Technical Service Information

FORD AX4N-4F50N 1999-UP DELAYED REVERSE ENGAGEMENT-SLIPS IN REVERSE

Figure 1

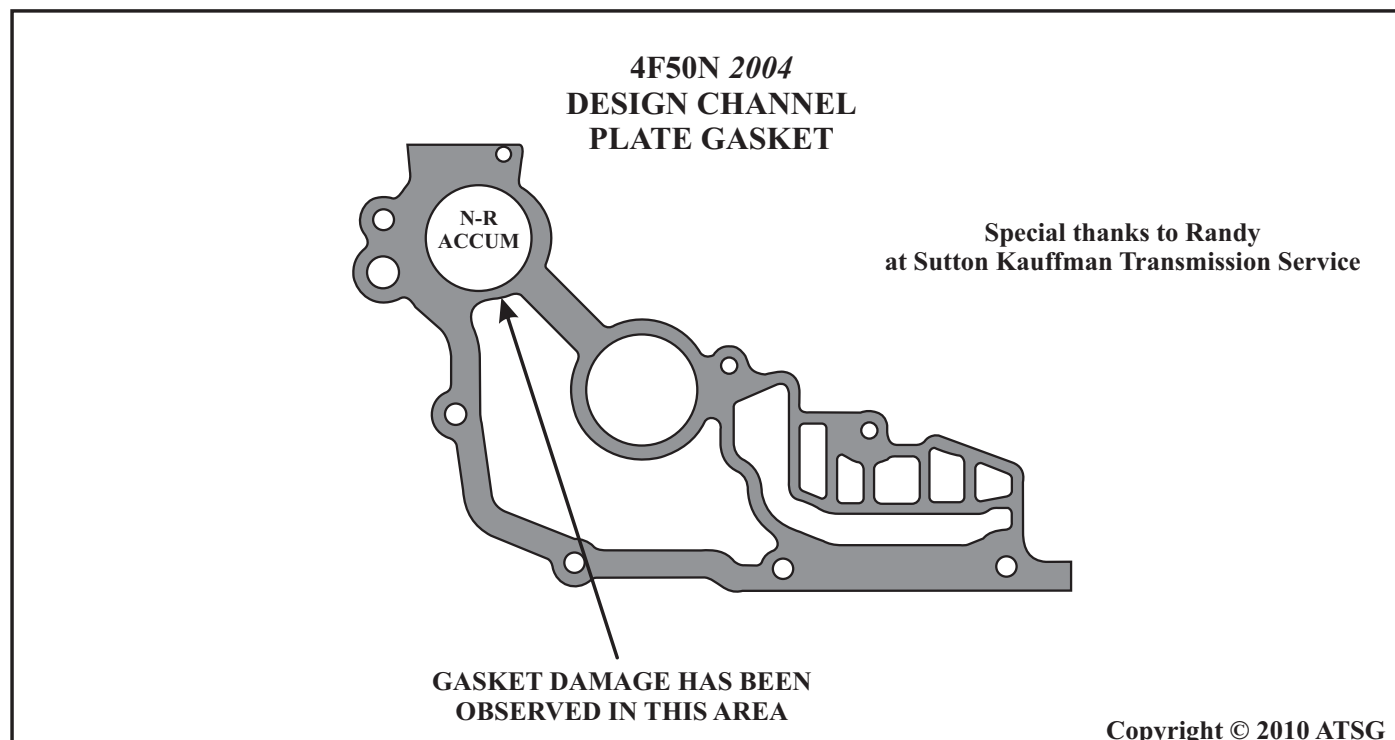
CAUSE: 1. Upon transaxle disassembly it may be observed that the channel plate gasket may be damaged at the N-R accumulator. (See Figure 1) This damage causes a fluid pressure loss to the reverse clutch pack resulting in either a delayed reverse engagement, or a slipping in reverse condition.

CORRECTION: 1. Currently all of the 2004-up channel plate gaskets that are now available have been updated to a new design level to prevent this problem from re-occurring. It appears that a change to the composition of the gasket material was made.

Figure 2

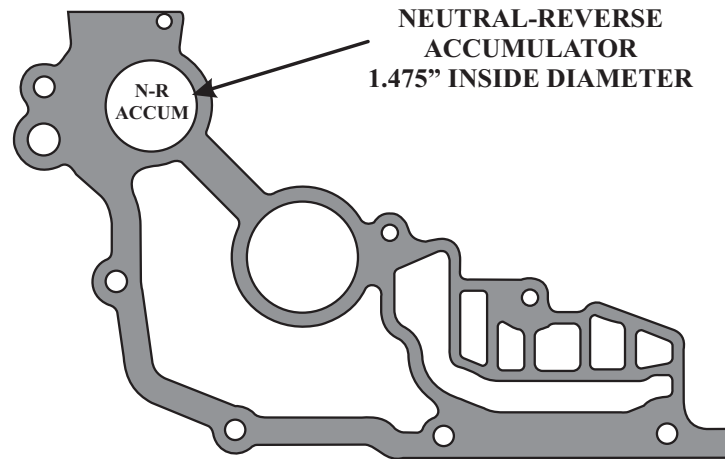
2. During overhaul, the wrong channel cover gasket may have been installed. For the model year 2004, the bore in the case where the N-R accumulator is was increased in diameter, and the channel plate gasket inside diameter was increased to accommodate the change.

2. During overhaul, make sure to use the proper channel plate gasket for your application. The 1999-2003 gasket is shown for identification (See Figure 2). The 2004-up gasket is shown for identification (See Figure 3).
